Temperature calculation in steel and composite beams

Proposal 1 - Item 4.2.5 of EN 1993-1-2

Proposal 2 - Item 4.3.4.2.2 (11) of EN 1994-1-2

prof. Lesław Kwaśniewski, Piotr Smardz

Proposal I - Item 4.2.5 of EN 1993-1-2

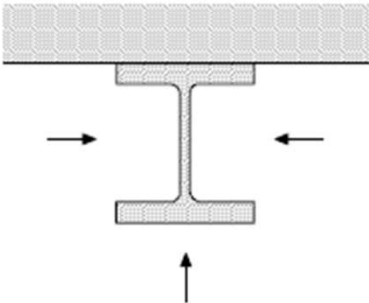
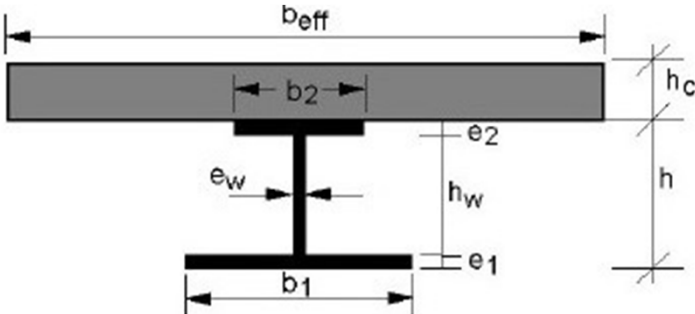
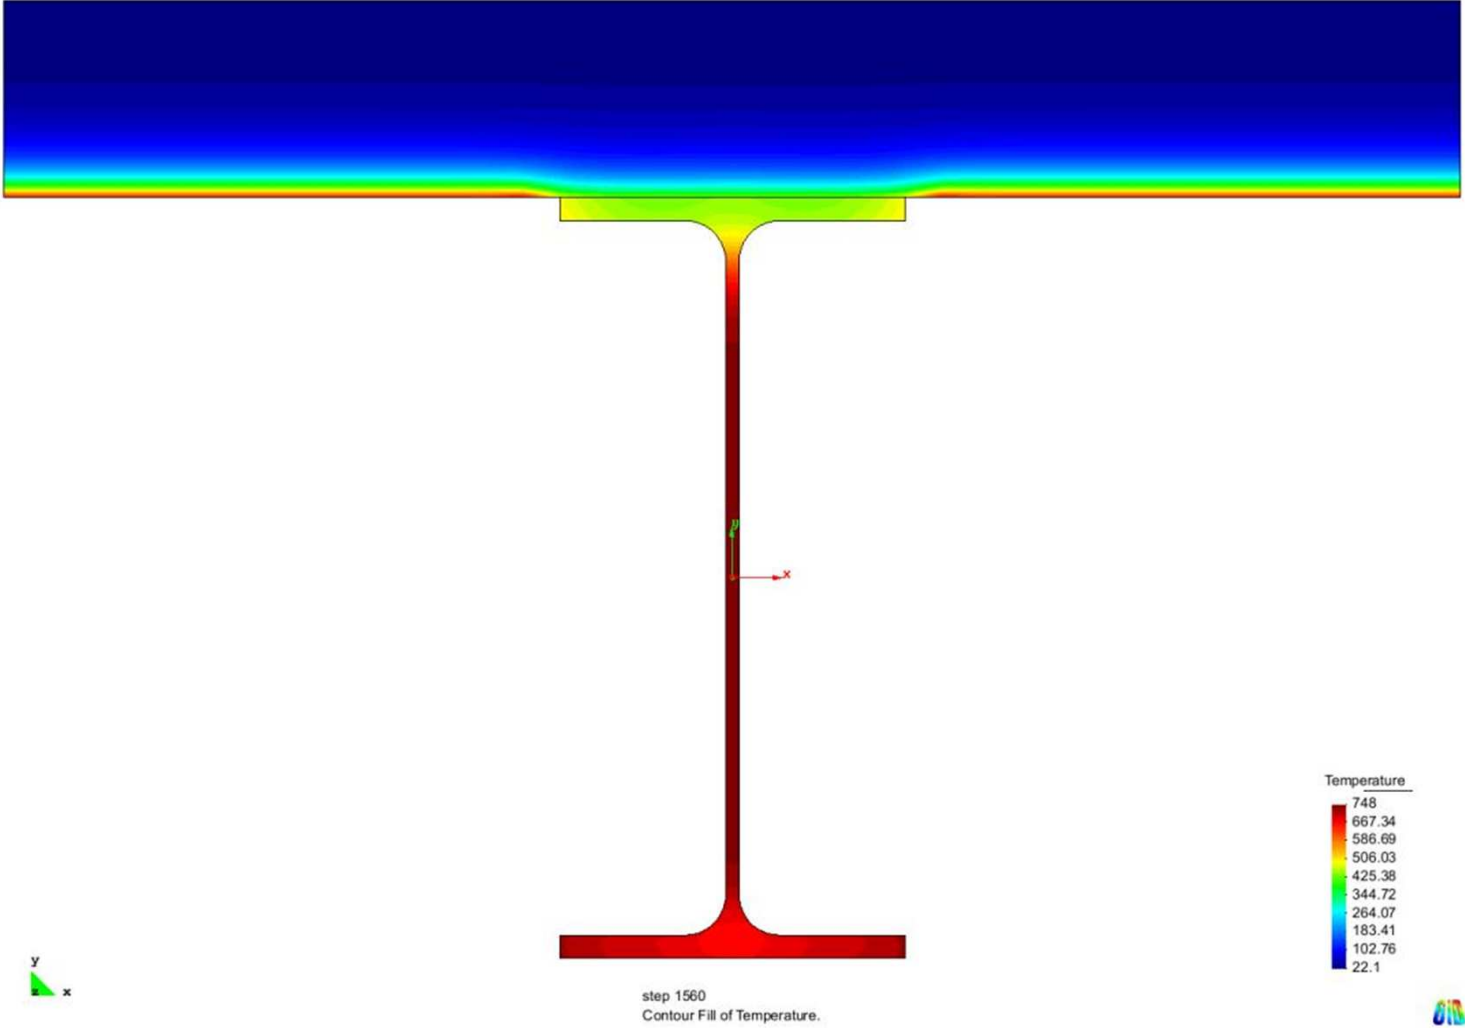
- ▶ For structural steel elements the calculation of temperature increase in an unprotected member exposed to fire is based on the assumption of uniform temperature field in the element. The formula for temperature increase is therefore based on a single section factor of the structural member (4.2.5 of EN 1993-1-2).
- ▶ For certain elements (e.g. large beams with tall webs supporting concrete floors) this assumption does not seem to be realistic.
- ▶ This approach is also not consistent with calculation methods for composite floor presented in EN 1994-1-2
- ▶ For beams / columns with 4-side exposure the assumption of uniform temperature seems to be realistic

- ▶ Provide criteria when it is appropriate to assume uniform temperature distribution in a steel beam, and when it is more appropriate to split the member notionally into different parts, each having uniform temperature – in the same way it is done for composite beams

Proposal 2 - Item 4.3.4.2.2 (10) of EN 1994-1-2

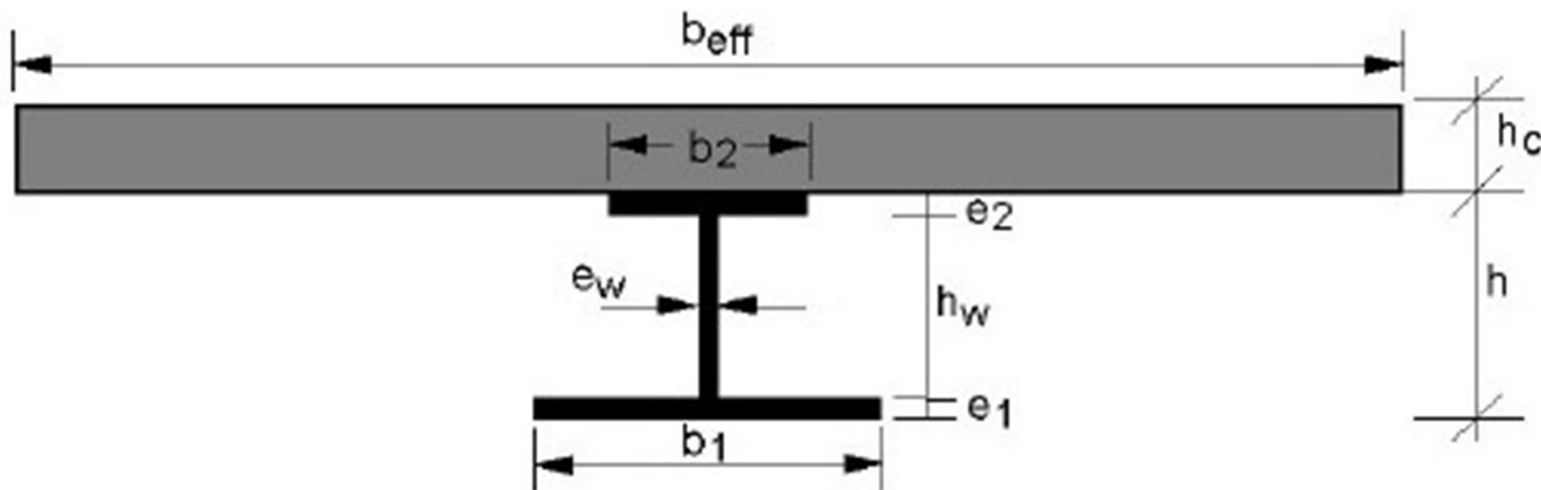
„If the beam depth h does not exceed 500 mm, the temperature of the web may be taken as equal to that of the lower flange”

No limit is set for the ratio of section factors for the web / flange or the minimum thickness of the flange.

- ▶ Provide additional criteria for the limiting ratio of the web thickness to lower flange thickness (or section factor) beyond which the temperature of the web needs to be calculated and not taken as equal to that of the bottom flange
